Technical Service Information

THM 3T40 (125C) HARSH 1-2 SHIFT

Figure 1

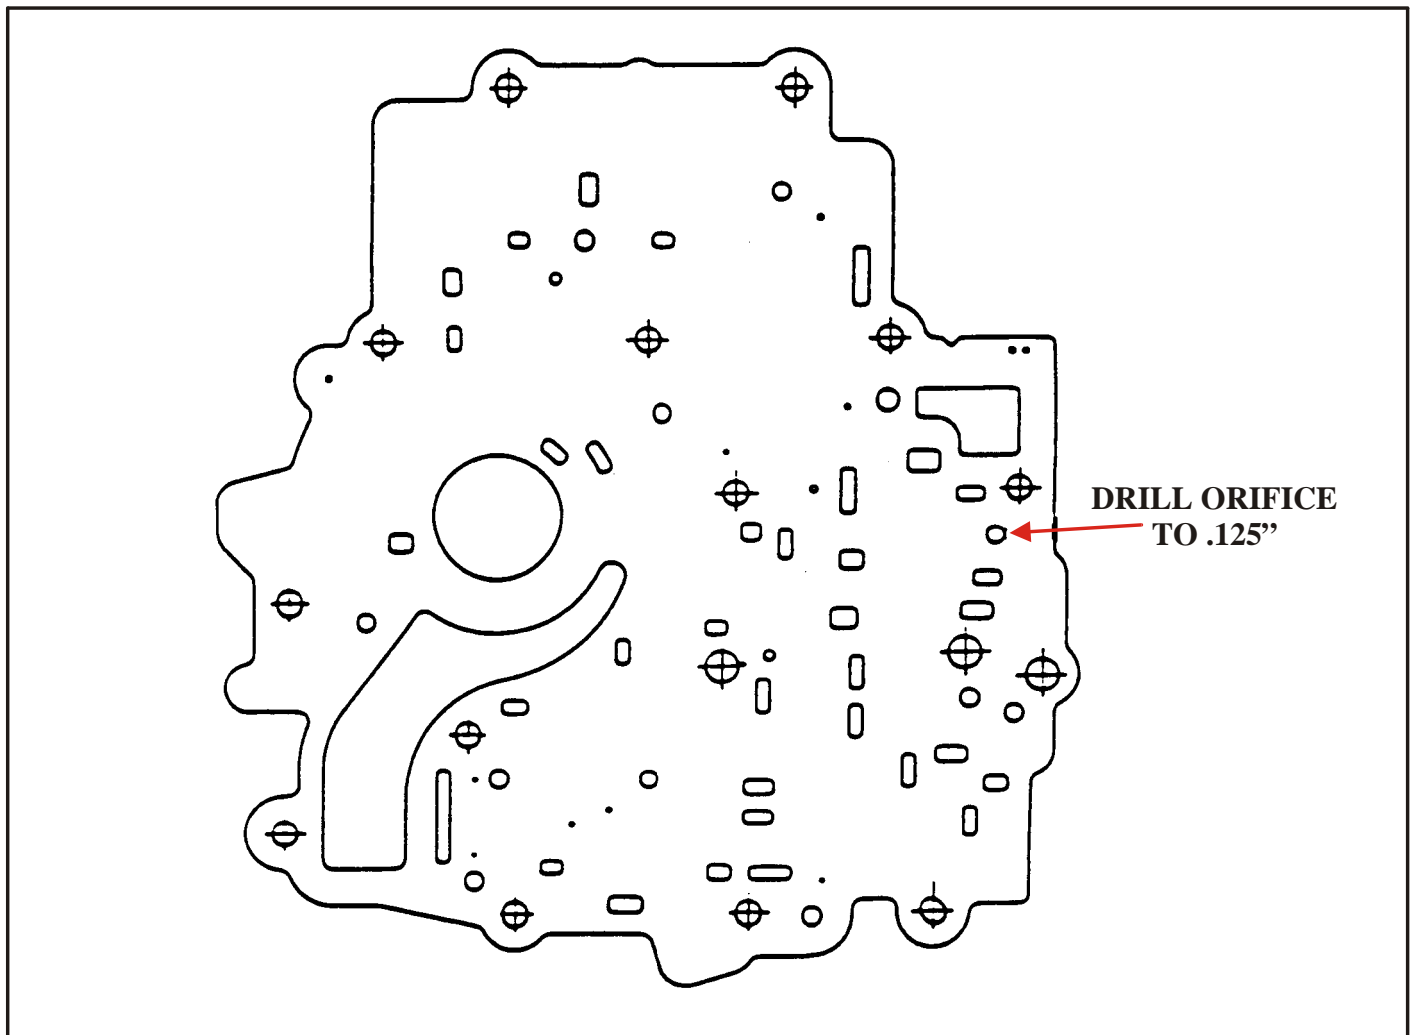
COMPLAINT: Harsh 1-2 shift encountered on 1985-86 Thm 125C transmissions.

CAUSE: Too small an orifice in separator plate (.040) 1-2 ACCUMULATOR FEED BACK ORIFICE.

CORRECTION Drill orifice to (.125) or replace with part number 8660581
